# INNER WEST COUNCIL

## DEVELOPMENT ASSESSMENT REPORT

<b>Application No.</b>	201700486
<b>Address</b>	39-41 Roberts Street, St Peters
<b>Proposal</b>	To consolidate the existing allotments into 1 allotment, demolish existing improvements, remove trees, carry out a Torrens Title subdivision of land into 5 allotments and construct a 2 storey dwelling house on allotments 1 and 5 and a 3 storey dwelling house on allotments 2, 3 and 4
<b>Date of Lodgement</b>	6 October 2017
<b>Applicant</b>	Environa Studio
<b>Owners</b>	Prestige Developments Pty Ltd
<b>Number of Submissions</b>	10 submissions originally, 10 submissions re-notification.
<b>Value of works</b>	\$1,751,583
<b>Reason for determination at Planning Panel</b>	Number of submissions exceeds officer delegation
<b>Main Issues</b>	FSR, Car Parking, Streetscape/Materials and Finishes
<b>Recommendation</b>	Deferred commencement consent

NORTH-WEST ELEVATION  
SCALE: 1:100 @A3

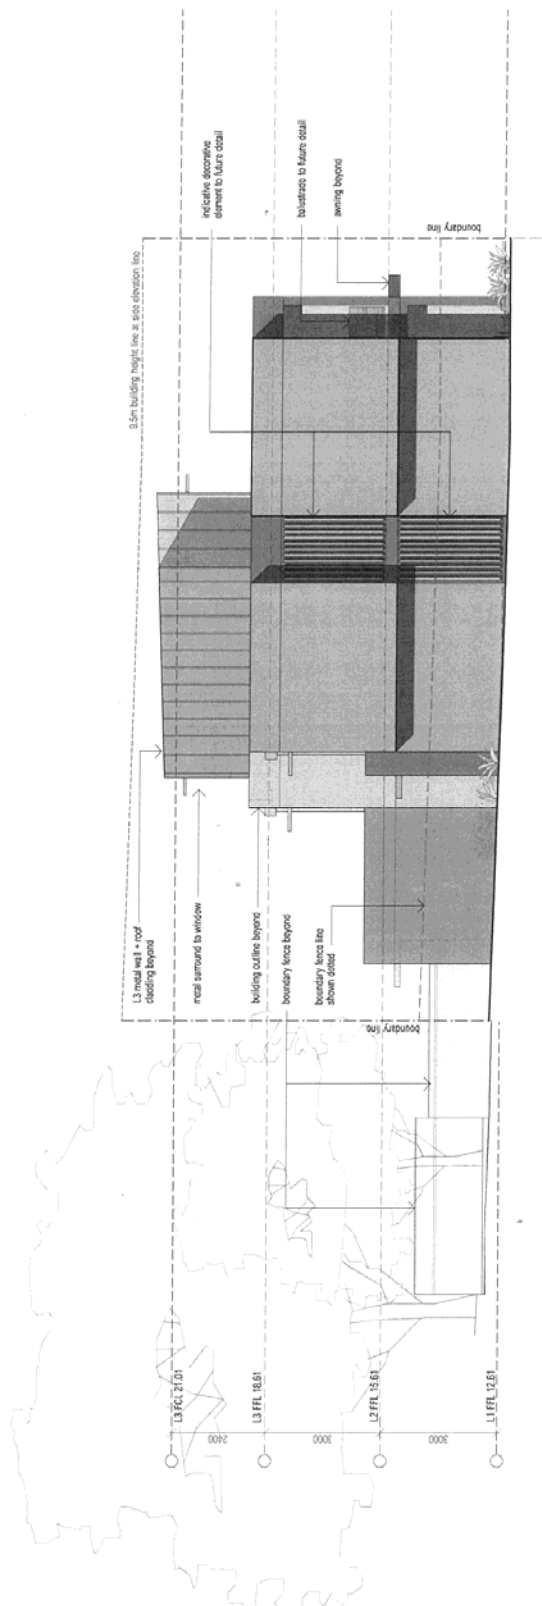
- d) *Complete specification and image of the 'decorative element' to the North-West Elevation to be provided in the schedule of finishes.*
  - e) *Complete specification and image of the balustrades to the front balconies to be provide in the schedule of finishes.*

SOUTH-EAST ELEVATION  
SCALE: 1:100 @A3

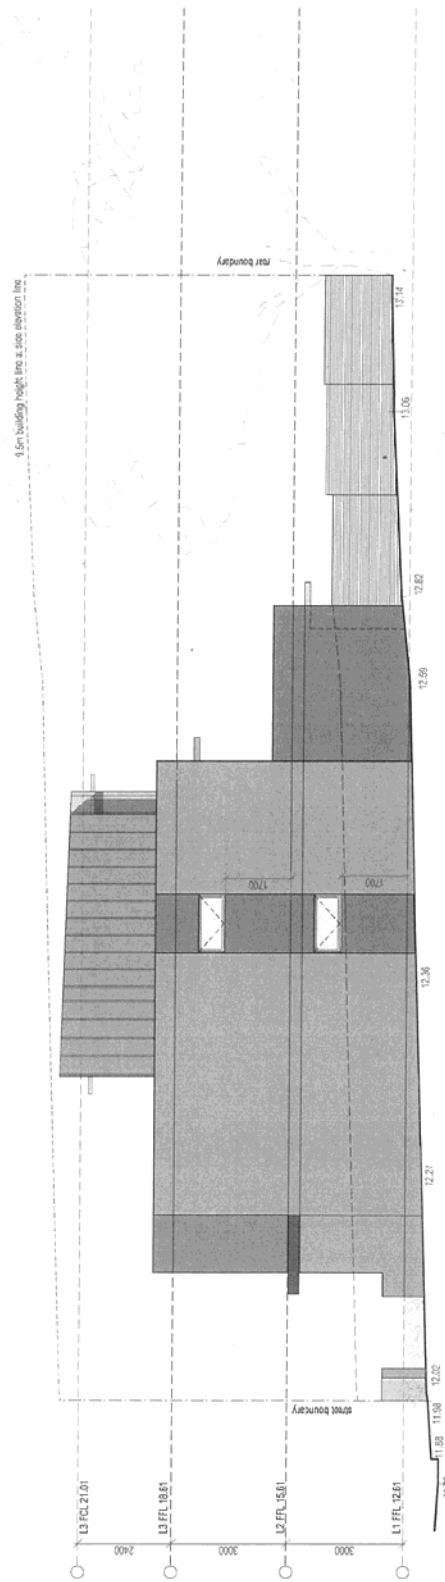
The windows along the south eastern elevation of terrace 5 are highlight windows with a sill height of 1.7 metres and thus no concern is raised over these windows in regards to privacy. It is noted that the ground floor plan does not indicate a window in this location which is inconsistent with the elevations provided. A deferred commencement condition is included in the recommendation requiring this inconsistency to be rectified.

2. Amended Plans being submitted indicating the ground floor window on the south eastern elevation of terrace 5 being illustrated on the floor plan.
